**ADDITIONAL MATERIALS FOR THE
PLANNING COMMISSION MEETING**

MEETING DATE: May 8, 2012

AUKE LAKE WAYSIDE

CONCEPT PLAN AND DETAILS, April 2012

Location of our home

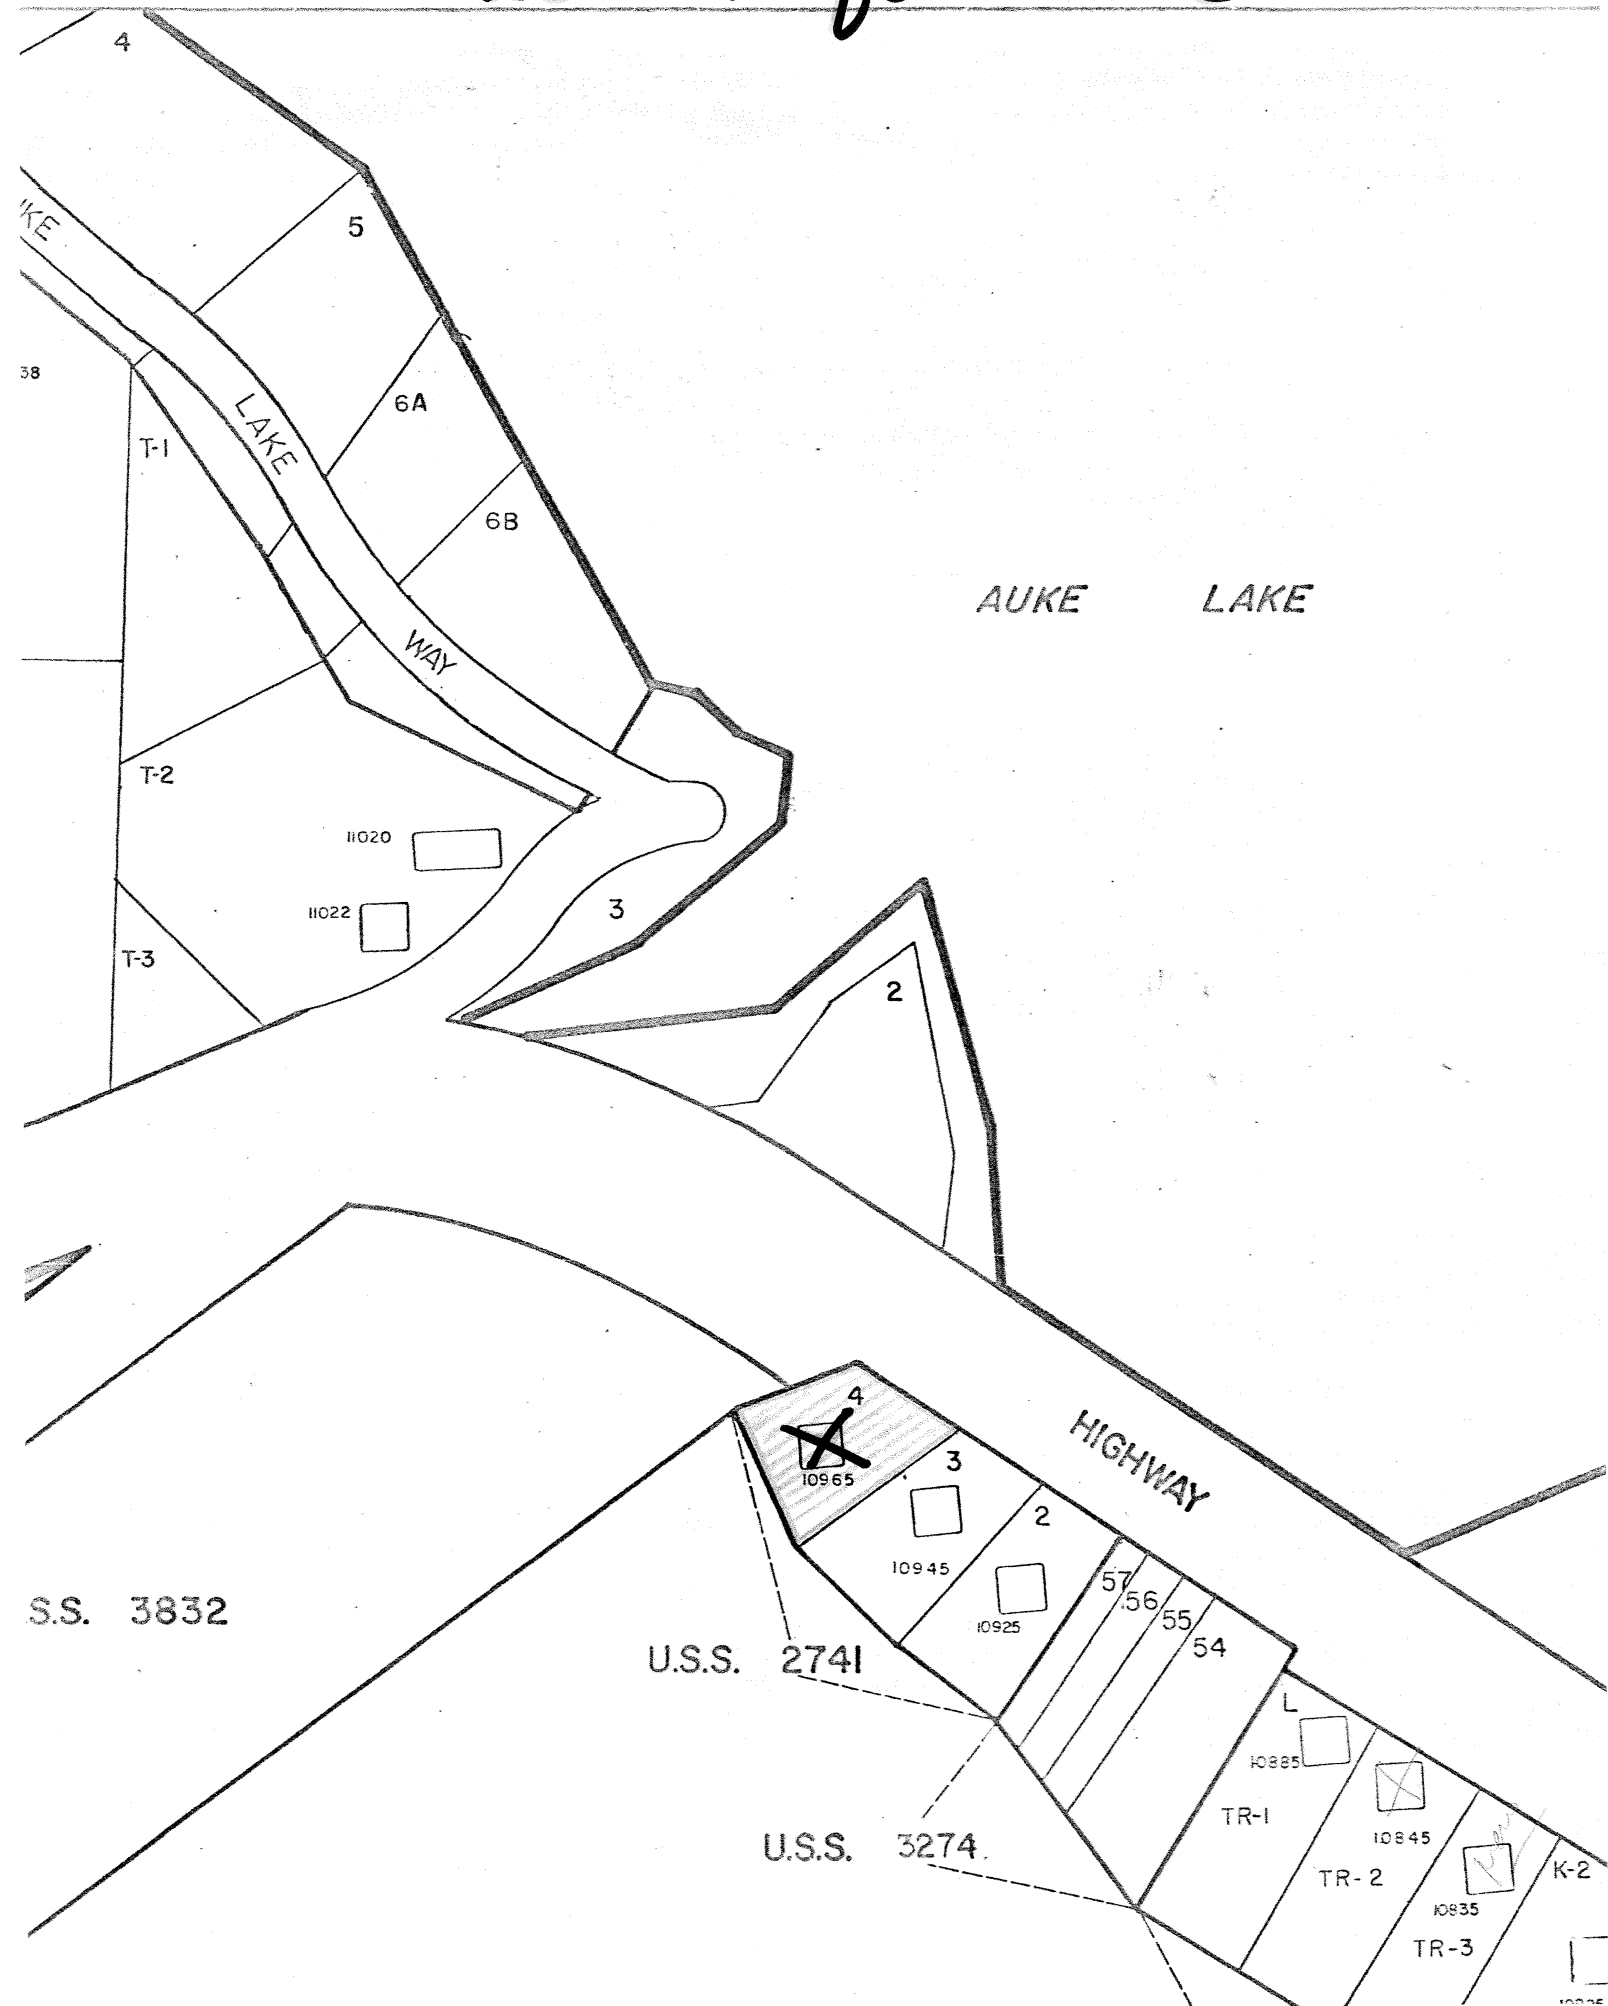
We live across Glacier Highway from the Auke Lake Wayside and have some concerns with the proposed "improvements." Prior to DOT's road widening project in the late 1970s our house had safe, off road parking on our side of Glacier Highway. Because that was eliminated, DOT created parking spaces for our cars and/or boat behind the guardrail directly across from our house. (This now sits between the guardrail and the launch ramp. Please consider this in your new plan.) We are also concerned about winter parking. At this time we pay to have 5 spaces plowed on the east side to accommodate our three vehicles and guests. With the entrance further away, this will not only greatly increase our walk along icy snow berms, carrying parcels and with pets, but double our plowing costs. (Our experience has been that unless the vehicles are parked right across from the house, vandalism and theft increase.)

Another personal concern is the placement of the bathroom. It will sit right in line with our view and block the spectacular view for motorists driving by on Glacier Highway. Please consider putting it near where the outhouses are currently placed.

1. Parking for private landowner in Auke Lake Wayside Right of Way:
The concept plan shows the ADOT Right of Way line, the boat launch ramp is in the Right of Way and the CBJ has an easement with ADOT for the use of this land. As part of this project planning and future planning for the multi-use path, the ADOT has decided to close off the eastern entrance to the wayside. With the new boat launch ramp location, the turn was too tight off the highway and it was not a safe vehicle entrance. Also, boat trailer parking would be limited if this entrance remained open. ADOT has read this comment letter and tried to find an agreement with the landowner to allow parking for their home use in the wayside, they have not been able to find any documented agreement.

2. Bathroom location:
The bathroom is located outside of the 50' setback from Auke Lake and adjacent to the boat launch ramp. Boat users will have easy access up the ramp to the bathroom without having to cross the parking lot. The existing port-a-potty location will be a surface stormwater treatment pond which is located in a bench area at the low end of the parking lot, where storm water is currently directed. Relocating the pond to accommodate the bathroom would cause much more fill, grading and potentially retentions structures to move the water in a different direction. The bathroom structure is approximately 12' tall x 10' long by 6.5' wide and none of the tall spruce tree vegetation around the edges of the lake will be removed. Any views from the road or across the road to the bathroom are obstructed more by the trees than the bathroom structure.

SHEET TITLE: CONCEPT NO. 1
BOAT RAMP
SCHEMATIC DESIGN
PND PROJECT NO.: 062087 DWG. FILE: 62078_BASE.DWG

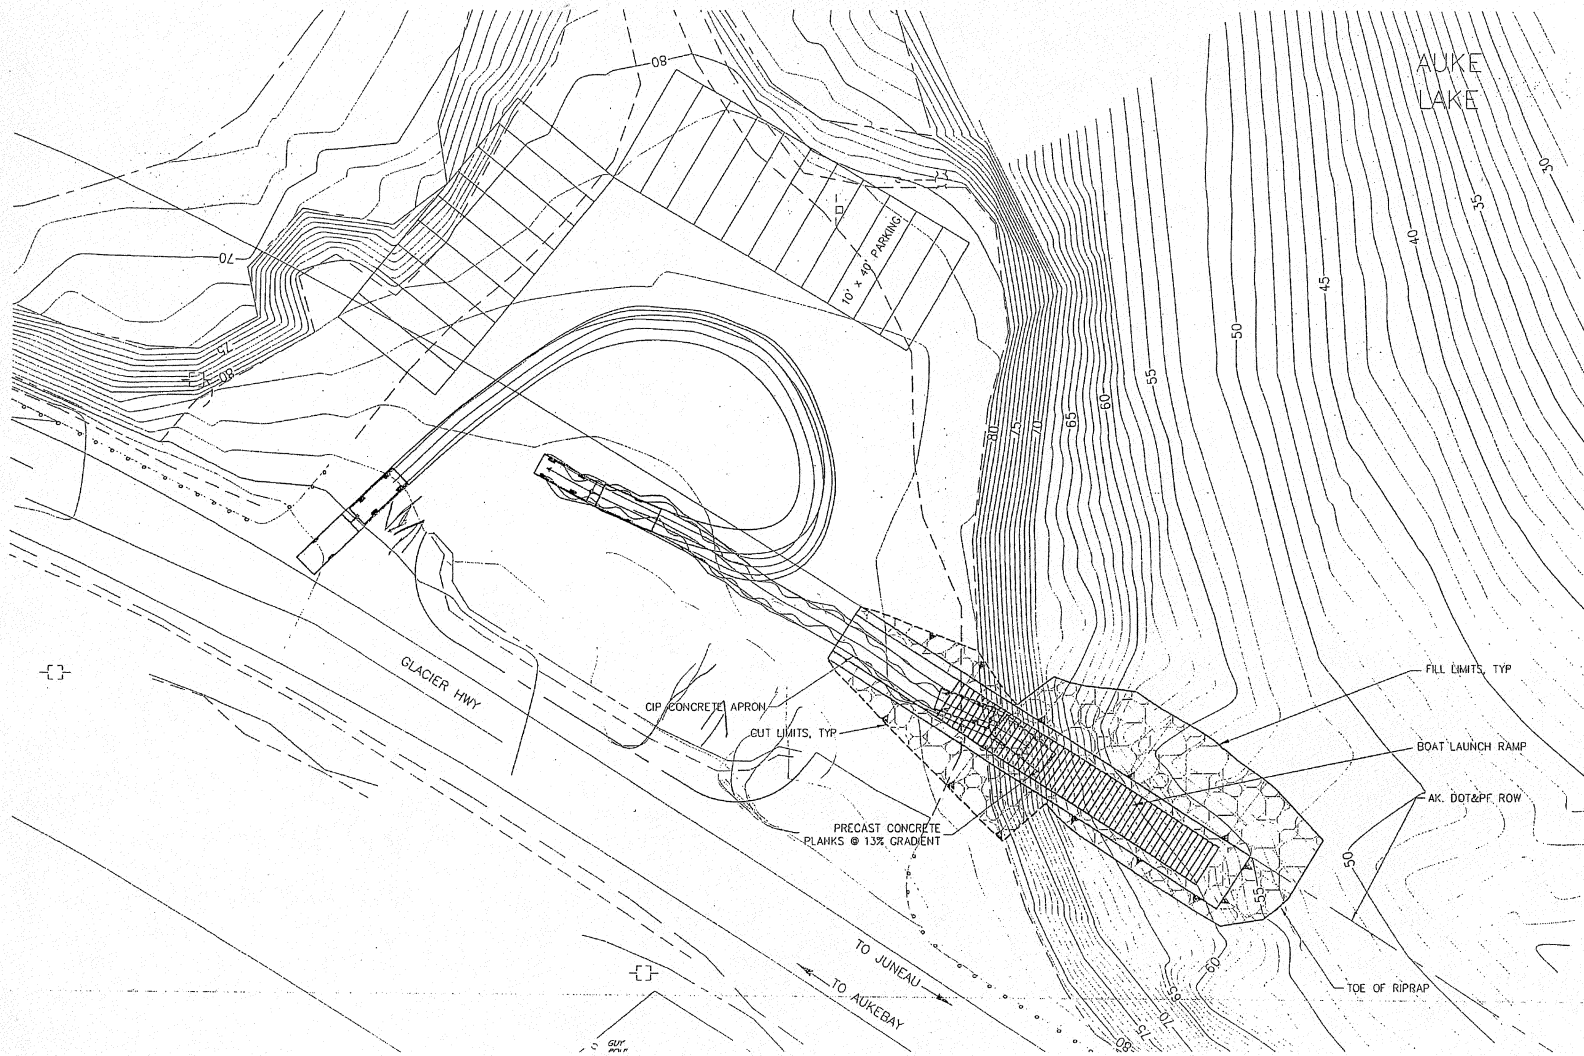
Our second concern is for the lake habitat itself where the launch site is present and where pre-spawning fish hold. The city was asked not to put the ramp in its current location, or if so, to incise the ramp into the parking lot so that less fill would be required to be dumped into the lake. Both suggestions were dismissed or ignored. Auke Bay Laboratories just finished stocking 50,000 sockeye fry into the lake as part of our long-term genetics work with UAF, funded by Pacific Salmon Commission Northern Fund. This project will impact the remaining lake habitat near the creek head waters. Our concern here is for silt fines or hydrocarbons from spills entering the either during construction or during use. This would degrade the habitat, particularly for the holding

2. The second concern is for lake habitat and comments on the CBJ's previous plan for locating and constructing the boat launch ramp.
 - a. During the planning and permitting process for the boat launch ramp, agencies requested that the fill footprint in Auke Lake for the new boat launch ramp be minimized. The strategy suggested was to cut into the existing wayside parking lot, push the ramp into the wayside and maximize the slope of the ramp. Please see the attached plans for the boat launch ramp. The plan marked Concept #1 shows the boat launch ramp in the existing location but sticking out into the lake, the plan marked Concept #2 shows the revisions with the ramp cut into the hillside and the ramp slope at 16%, the maximum allowable slope. Concept #2 was constructed. The concerns about hydrocarbons and stormwater reaching the lake are addressed in the design as detailed in the response to concern #1 above.
